MEMORANDUM

FILE NO.: SMP2014 0001

PROPOSAL: Preliminary Plat approval for a Major Subdivision of three lots to nine lots at the southeast corner of Sherwood Lane and Glacier Highway.

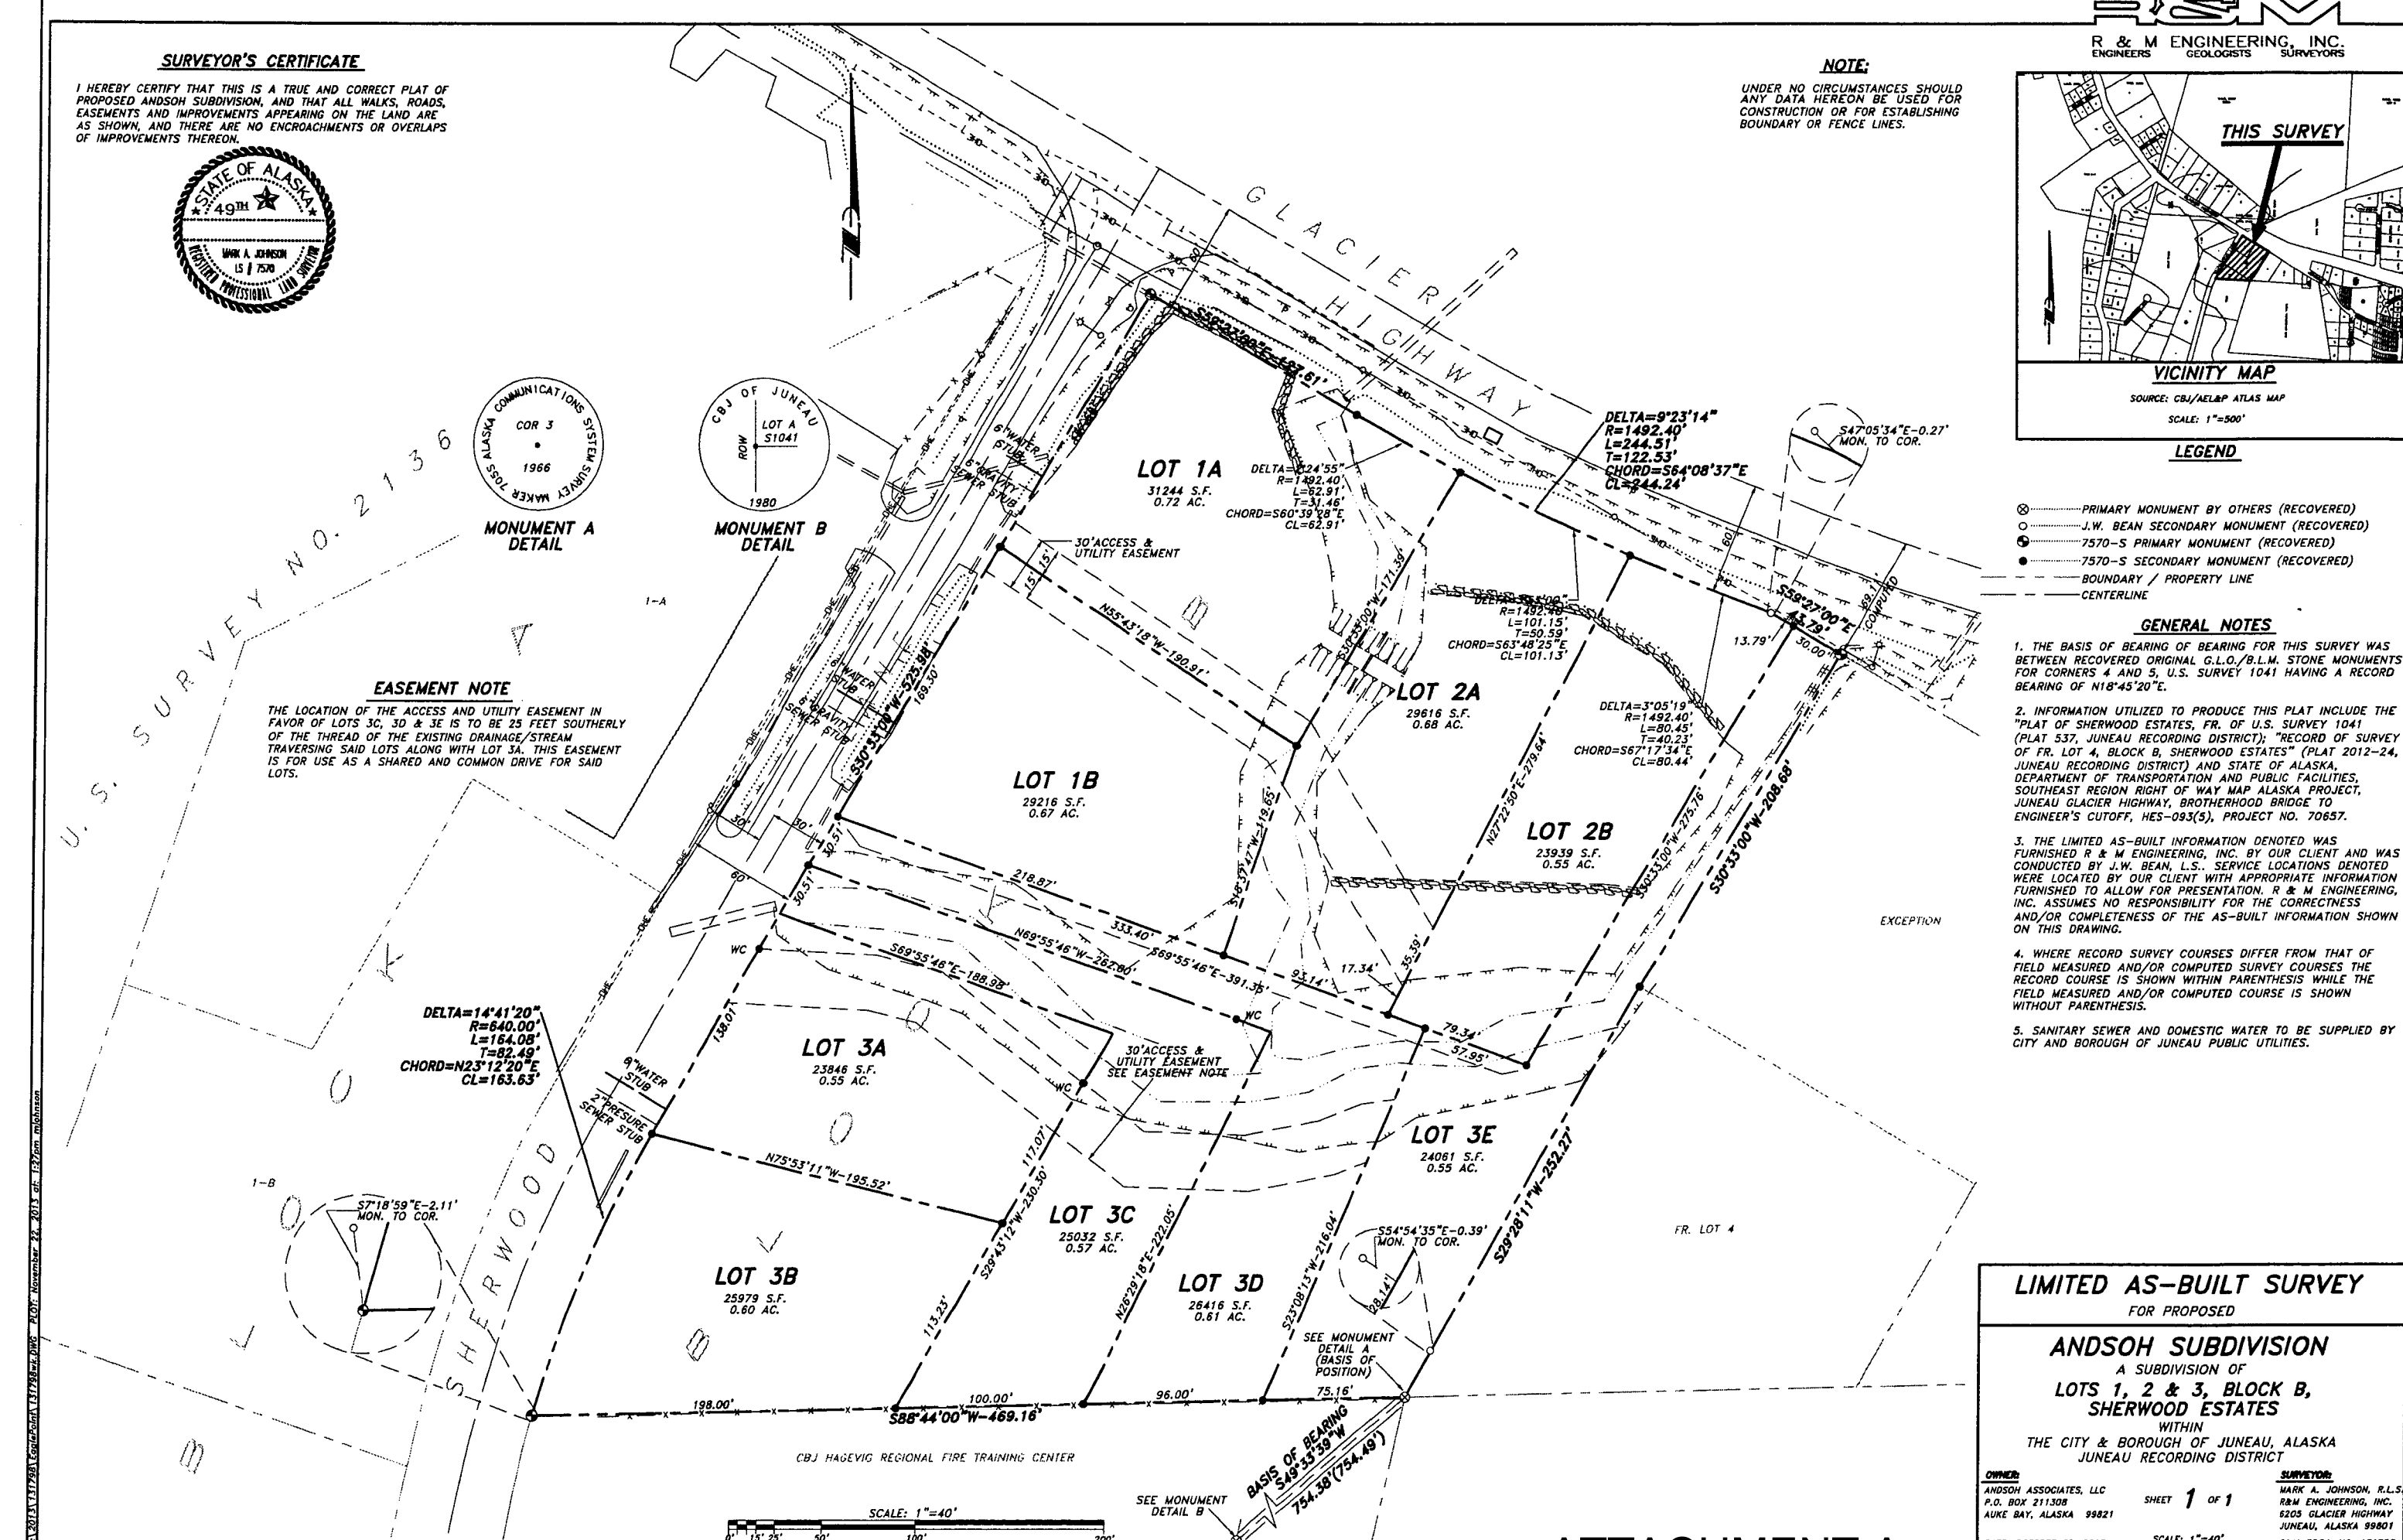
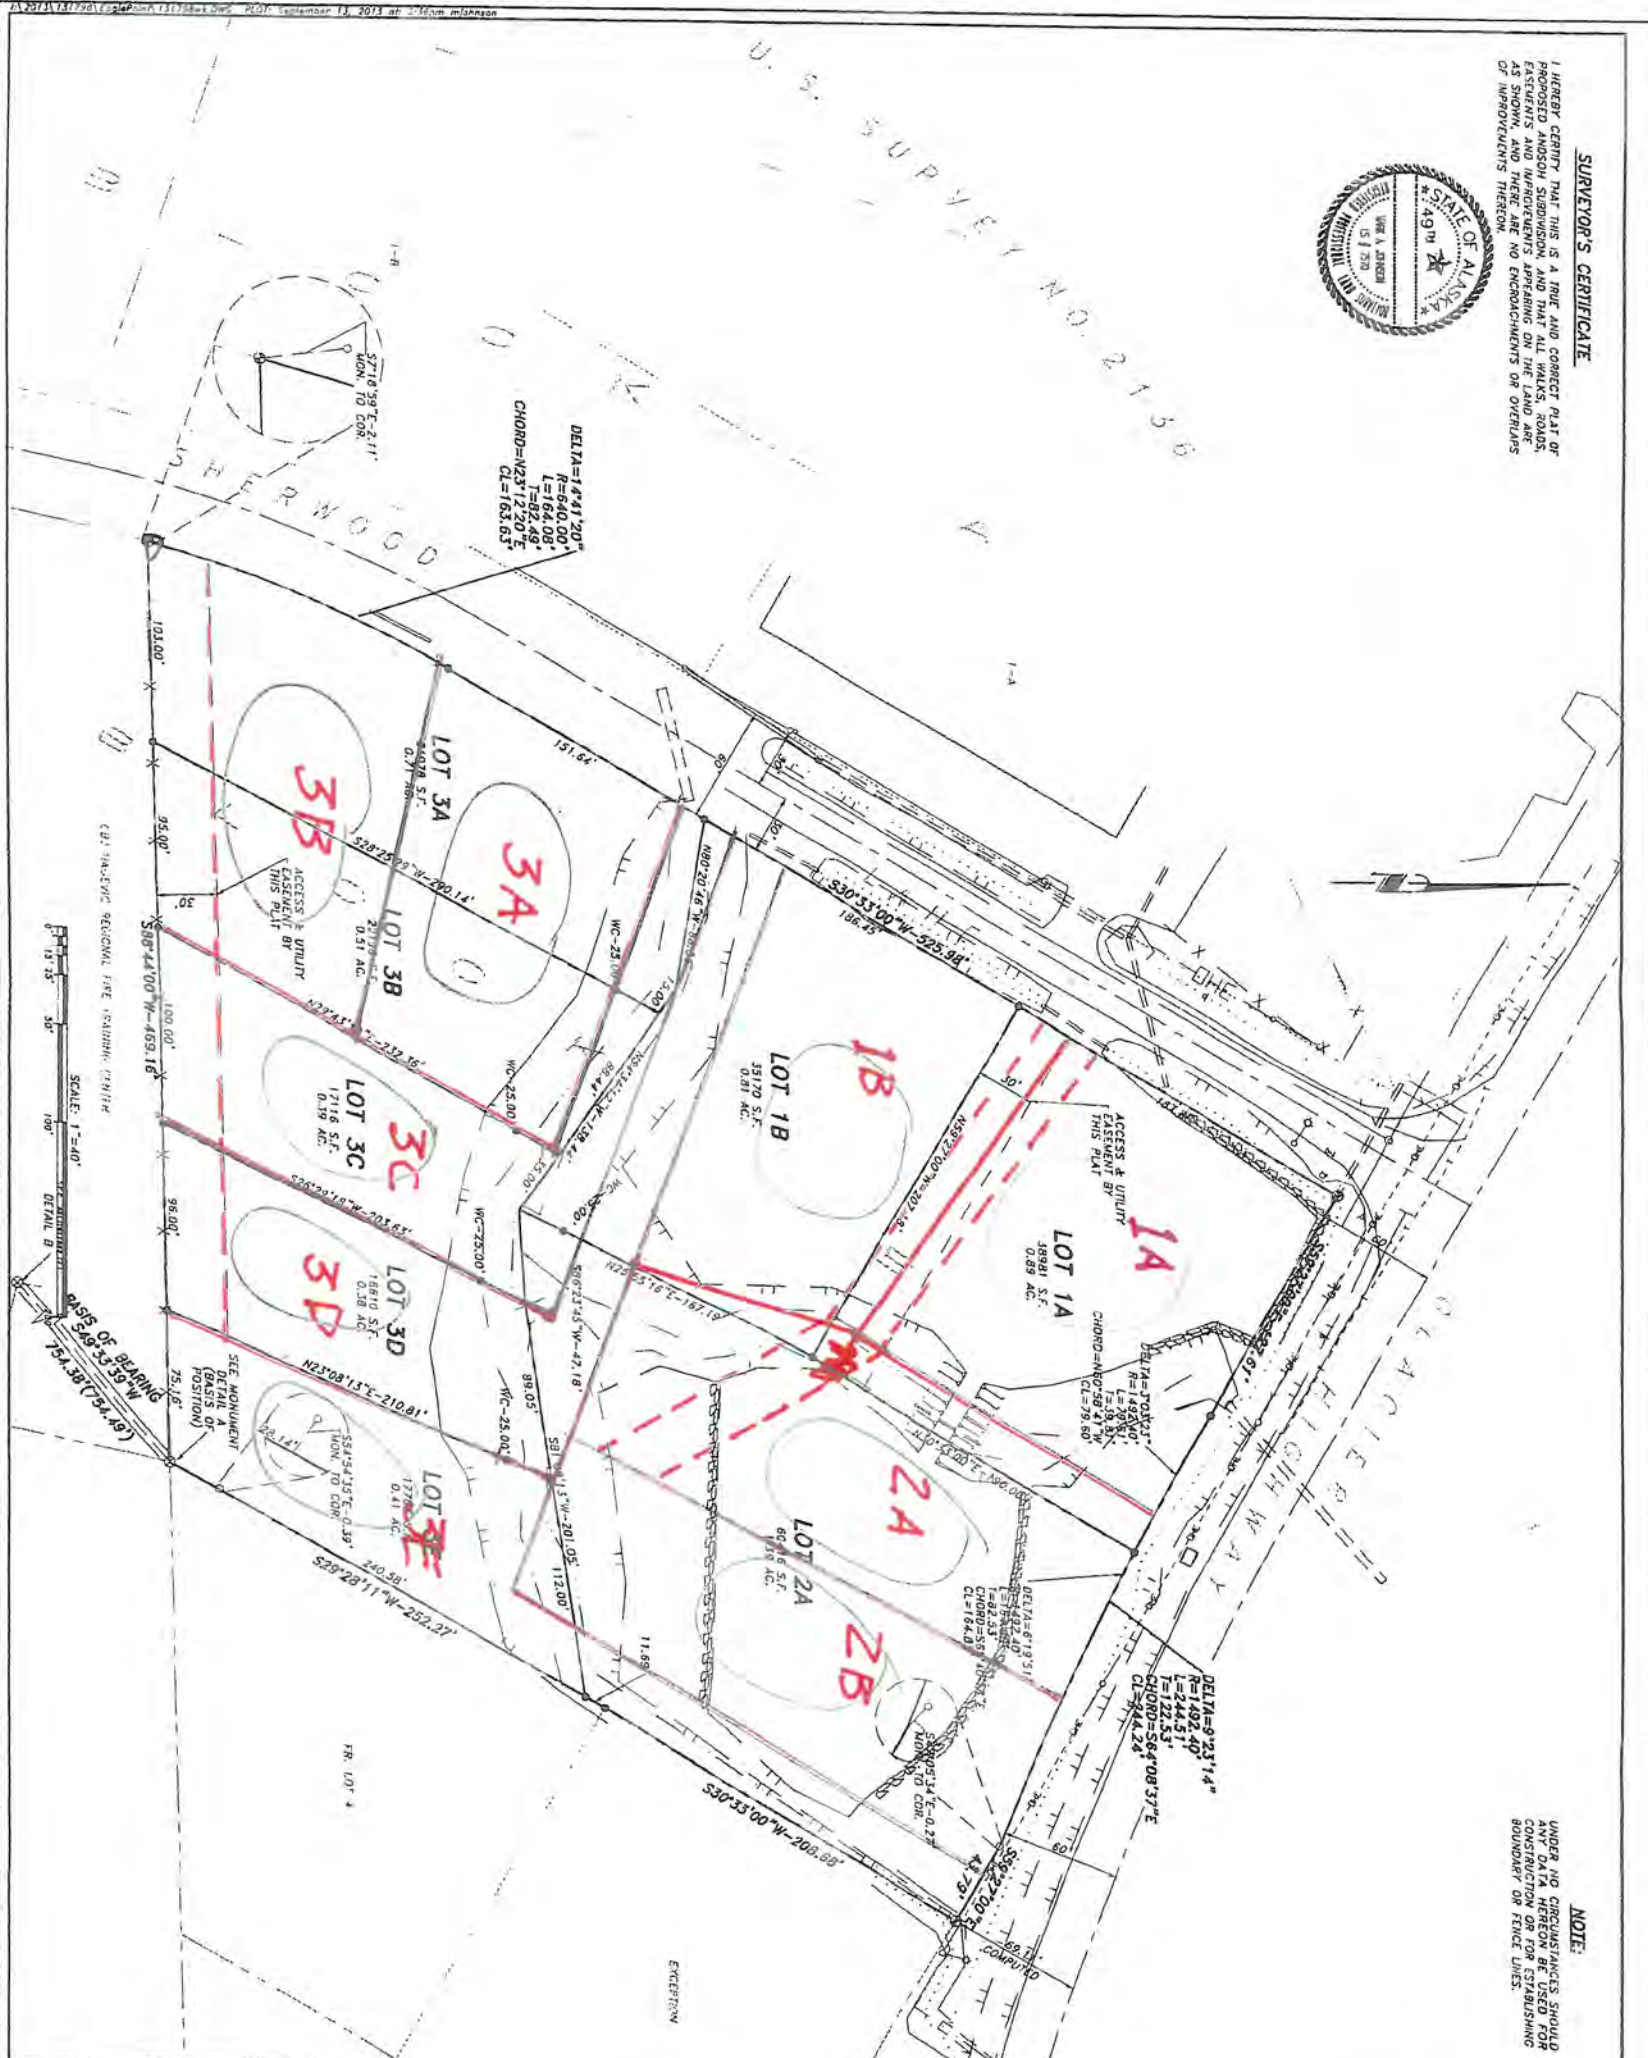
- Label adjacent lot to the south as USS 1041 Lot A
- Change label for adjacent lot across Sherwood Ln from 1-B to 2-A per plat 2001-55.
- Since a new subdivision is created, label new lots 1 through 9.
- Remove the ghosted font "BLOCK B" from over plat, as there is the added detail of the original lots.
- Add anadromous stream not

Add lot designations: Lot A, USS 1041 is the Hag-FTC and Tr A, USS 1041, property SE of subdivision.

Linetypes Easement, Property Line Vacated and tie (391.35') between corners all have the same linetype. Correct to individual line types and depict in legend.

Change all necessary dates to 2014.

Change to Corporate Ownership Certificate and reformat to the correct tense/signatory.

Add Corporate Ownership certificate for Lot 3 and correct title block.

Change the call within detail delineating the existing (vacated) corner of Lot 2/3/fr 4 by JW Bean "MON TO COR LOT 2/3/FR 4" (May need to increase the size of the detail).

Submit a proposed utility plan on the as built.

Add Stormwater Runoff note.

Revise plat and resubmit to include, proposed utility plan and answer drainage question. A complete drainage plan will not be required but the outfall must be verified to include crossing other properties. Need to research common use ditches that run into the anadromous stream.
